Response to Submissions

Penrith Waste Recycling and Transfer Facility

Penrith Waste Recycling and Transfer Facility | SSD 16_7733

Report J16099RP2 | Prepared for Benedict Recycling | 15 November 2018

Site layout
 Penrith Waste Recycling and Transfer Facility
 Response to Submissions
 Figure 1.1

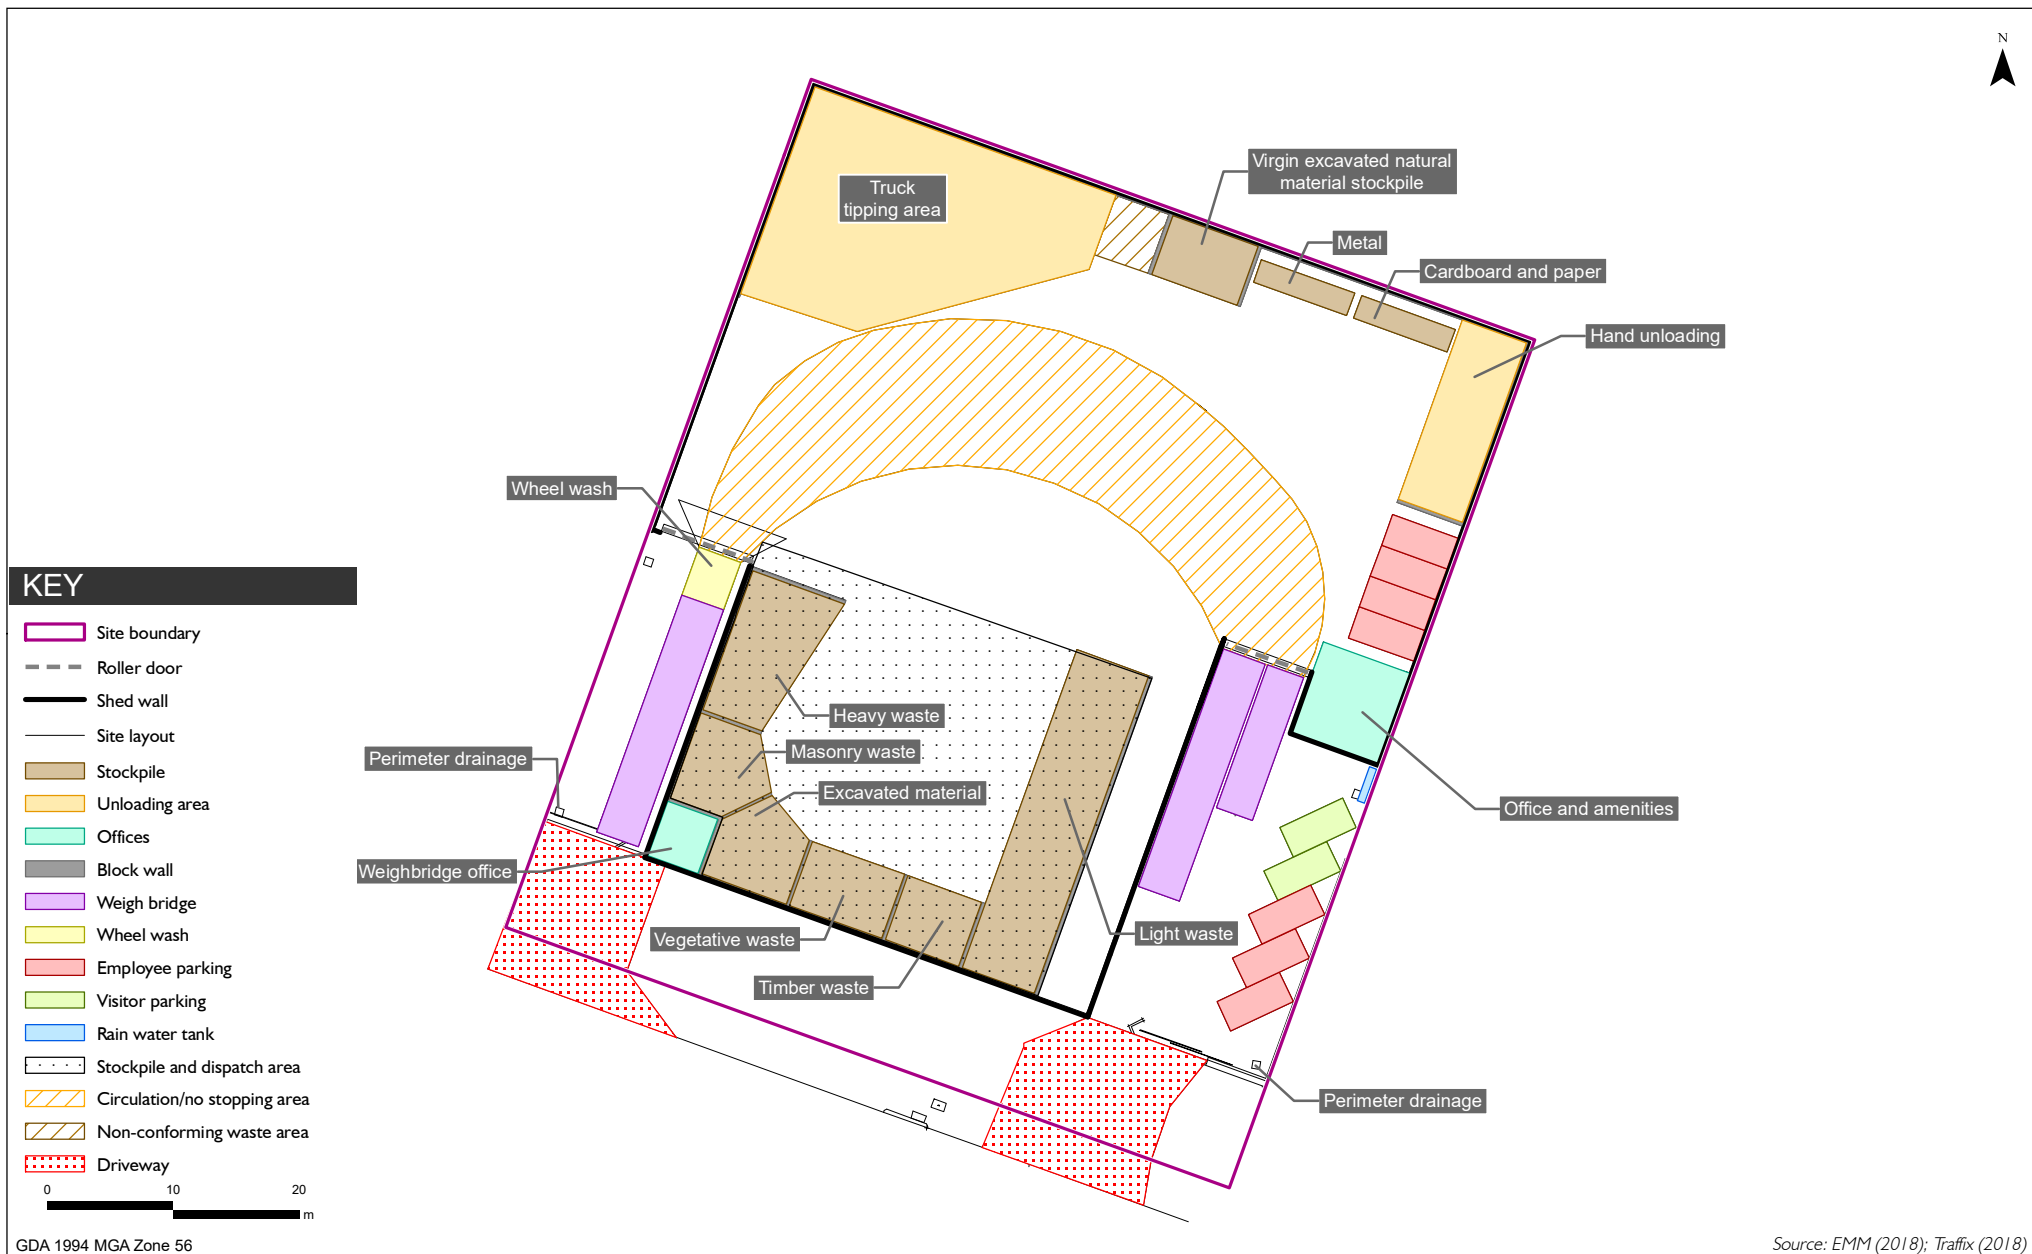
Service infrastructure pits are located on the verge within the road reserve. The box on the exit driveway as shown on Figure 1.1 represents one of these pits. The pit would likely be relocated to the east of the proposed driveway, with approval from the asset owner, with approval occurring as part of the post-approvals process.

Site line markings
 Penrith Waste Recycling and Transfer Facility
 Response to Submissions
 Figure 4.1

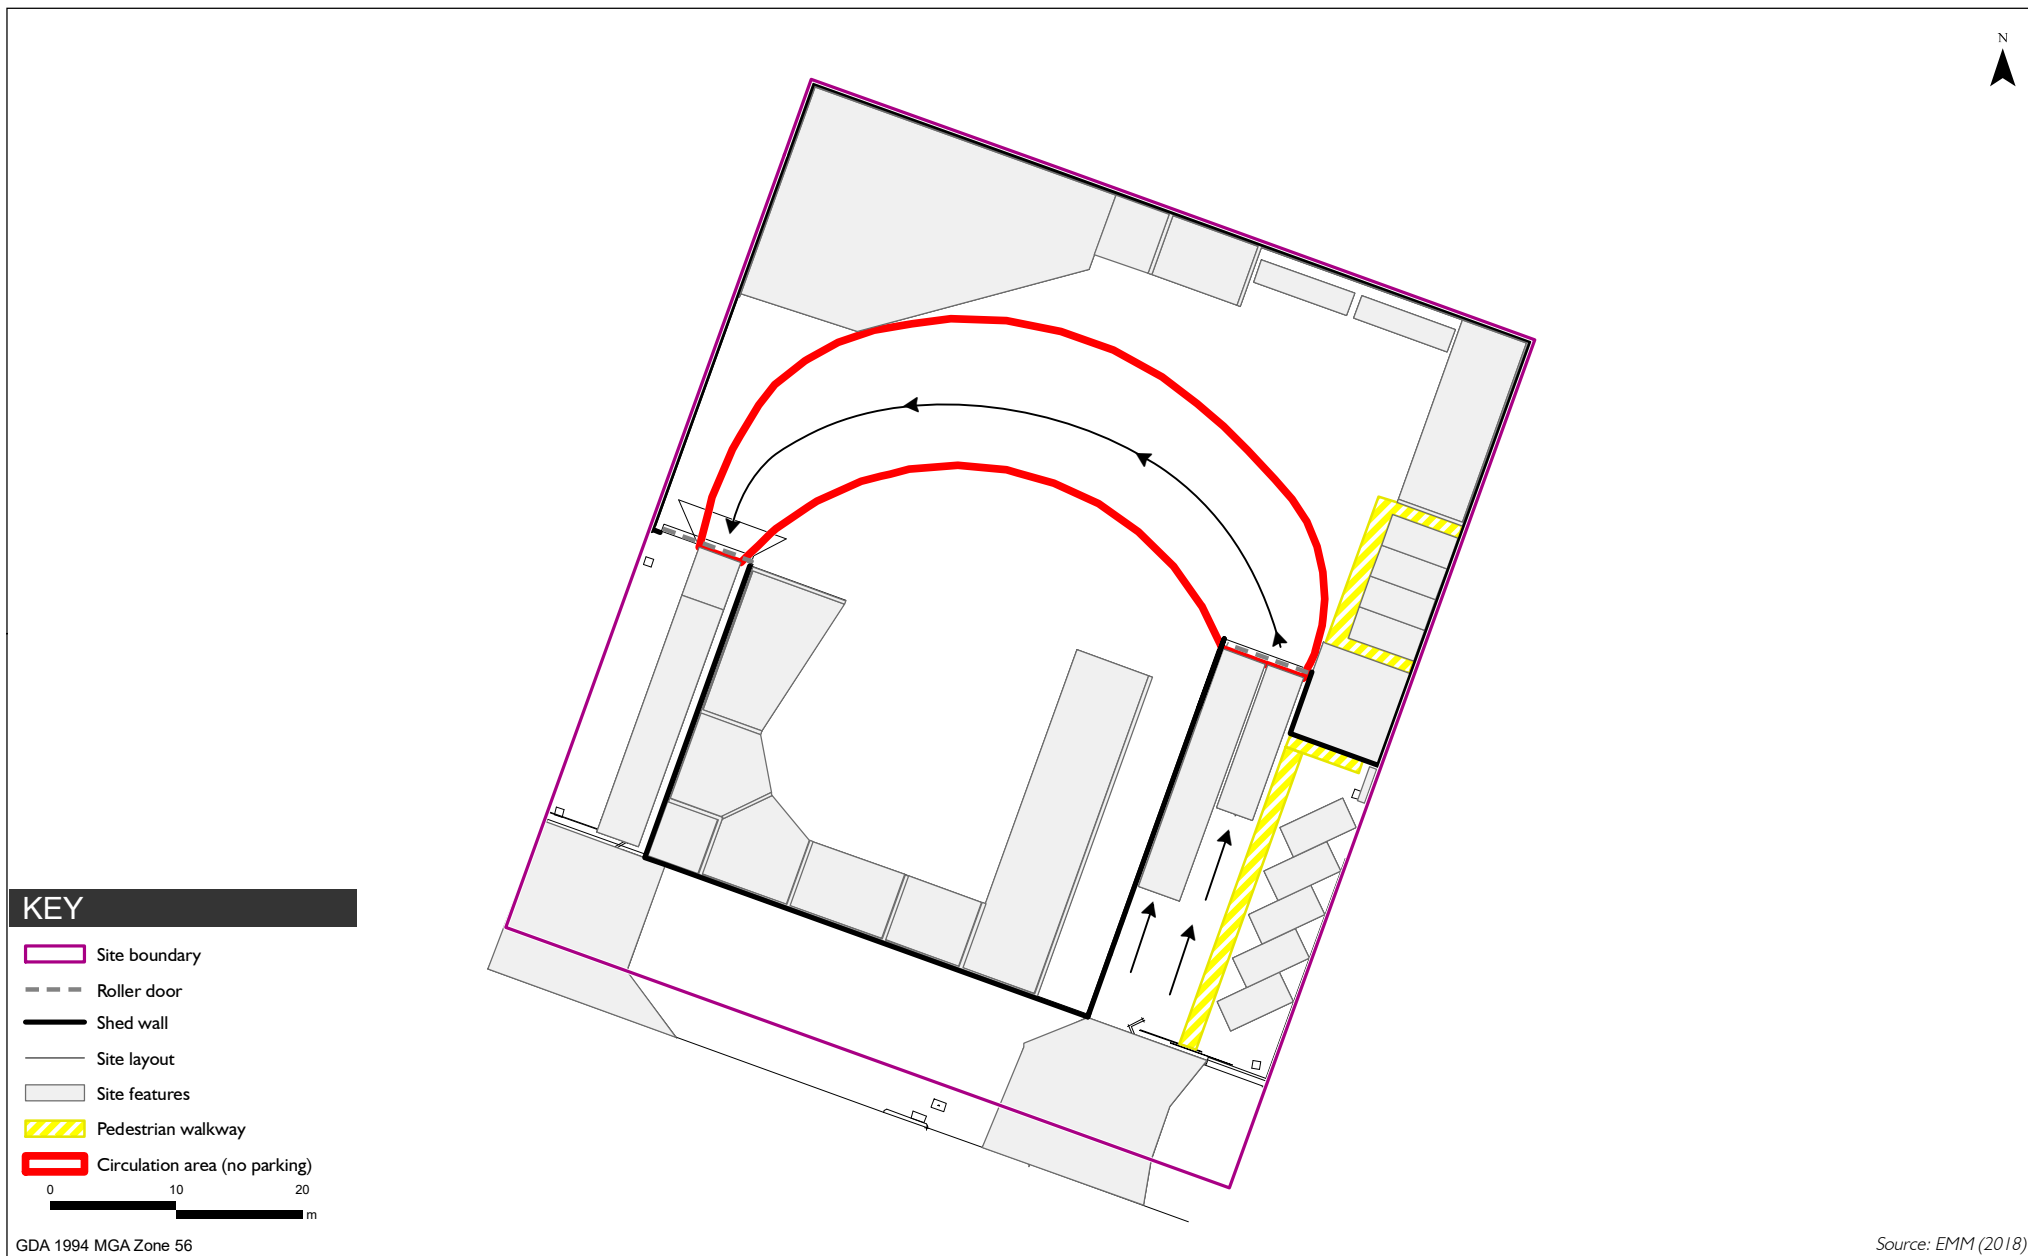
The circulation area shown in Figure 4.1 partially overlaps with the unloading truck figure on Appendix F Drawing TX.02. The circulation area, as shown in Figure 4.1, is an amalgamation of the common swept path elements from Appendix F and is meant to demonstrate the general nature of the management measure (ie that the common path of vehicles will be kept clear so that site plant and customer vehicles will not interact).

Proposed vehicle and pedestrian line marking areas are shown at Figure 4.1.

Line markings will designate lanes to the entrance weighbridges and circulation-only areas (ie travel paths between the entrance and exit weighbridges and unloading areas). The circulation area for the site is shown at Figure 4.1. These areas will be no-parking and no-unloading areas for customer vehicles, with stopping only permitted at the direction of site employees.

Pedestrian markings will identify pathways between the hand unloading area and site amenities without entering vehicle circulation areas.

Indicative fire safety measures
 Penrith Waste Recycling and Transfer Facility
 Response to Submissions
 Figure 4.2

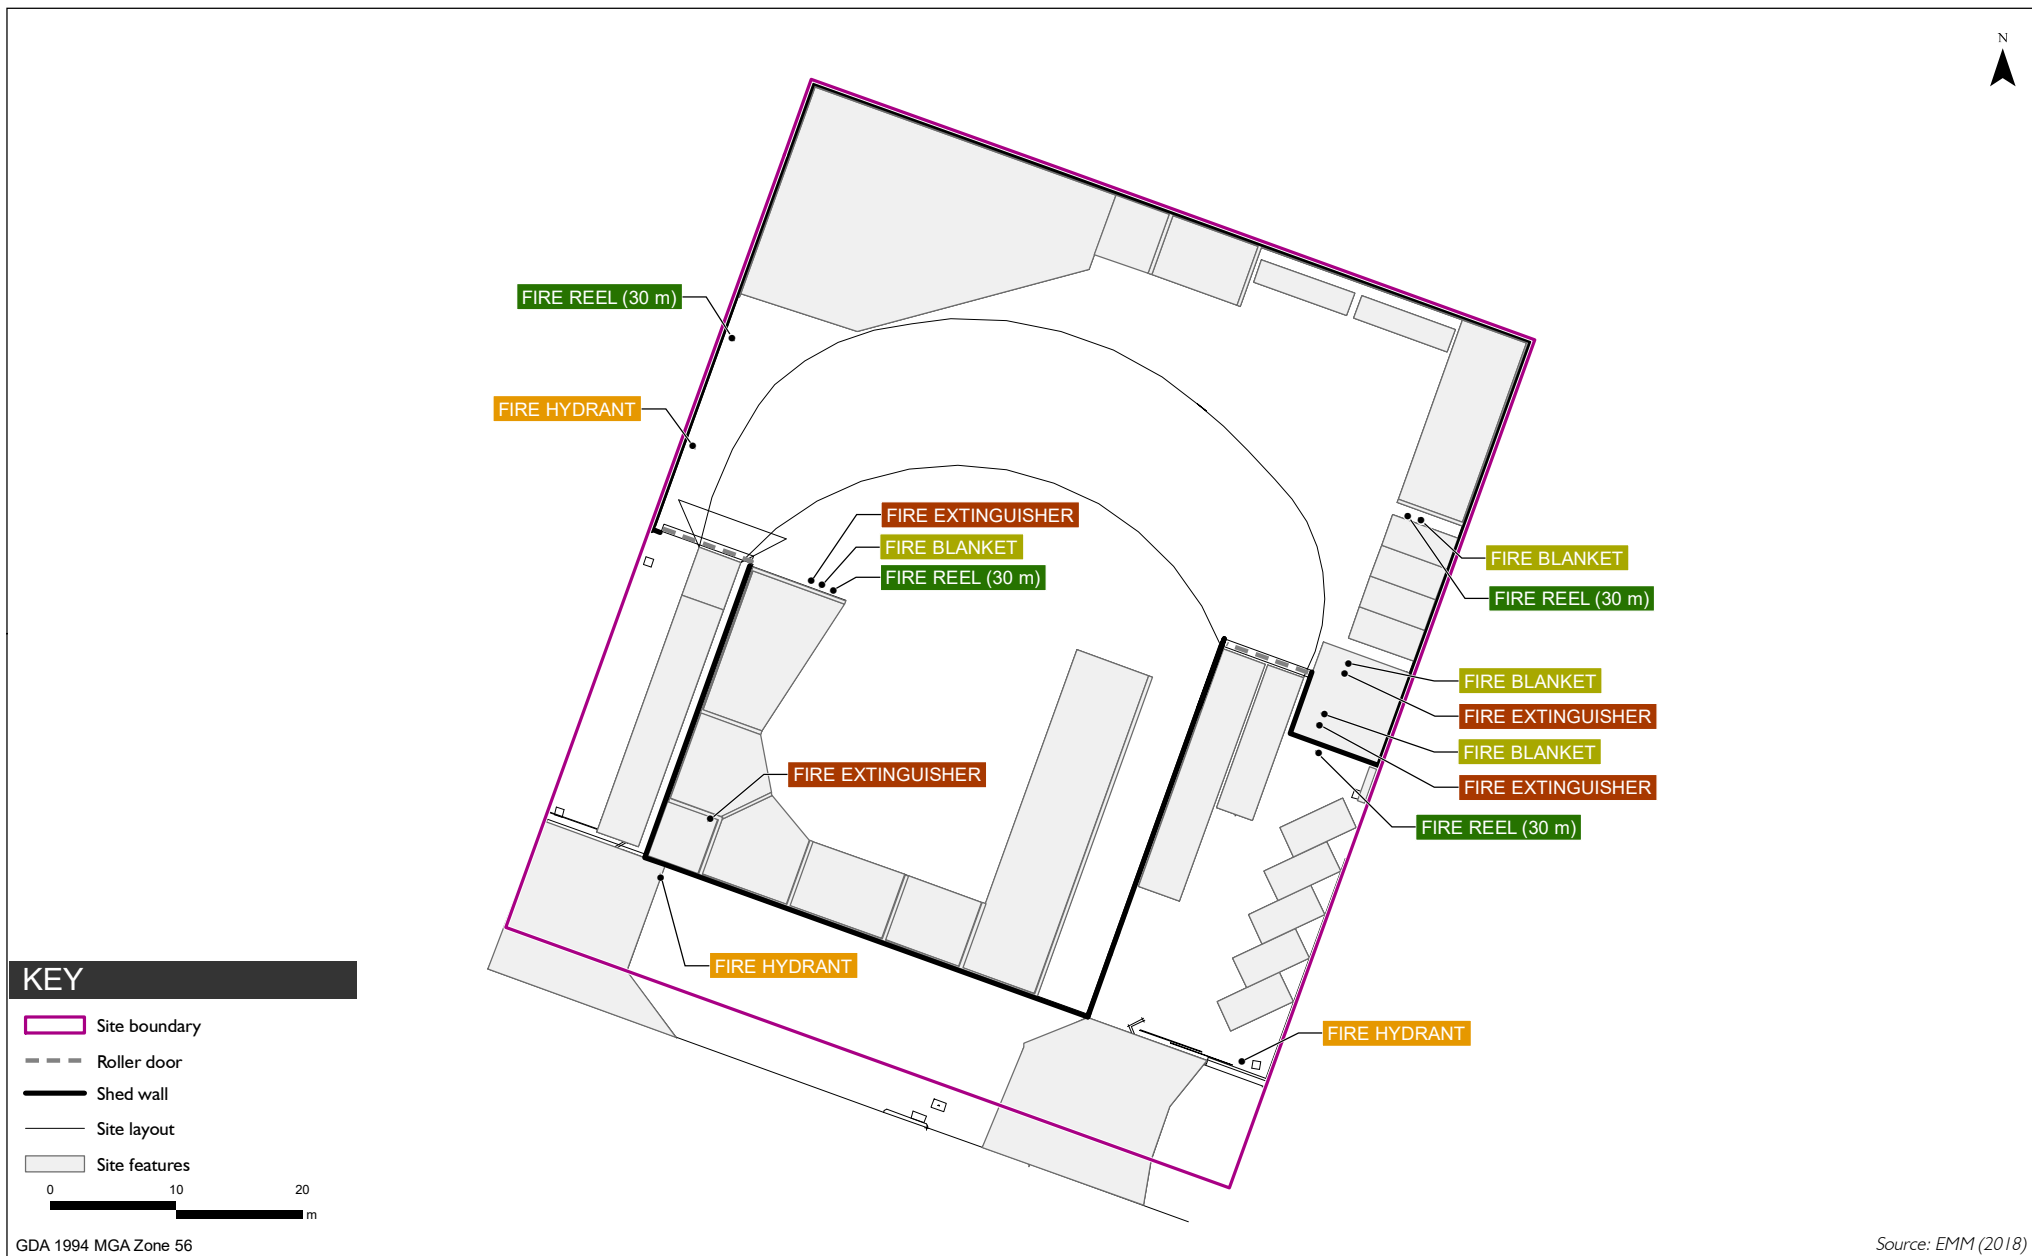
The proposed locations of fire safety measures are provided at Figure 4.2 and will be finalised as part of the detail design process in accordance with BCA provisions.

In summary, the following fire safety measures are proposed at a minimum:

- four fire hydrants;
- four fire extinguishers;
- four fire blankets;
- four fire hose reels; and
- smoke alarms.
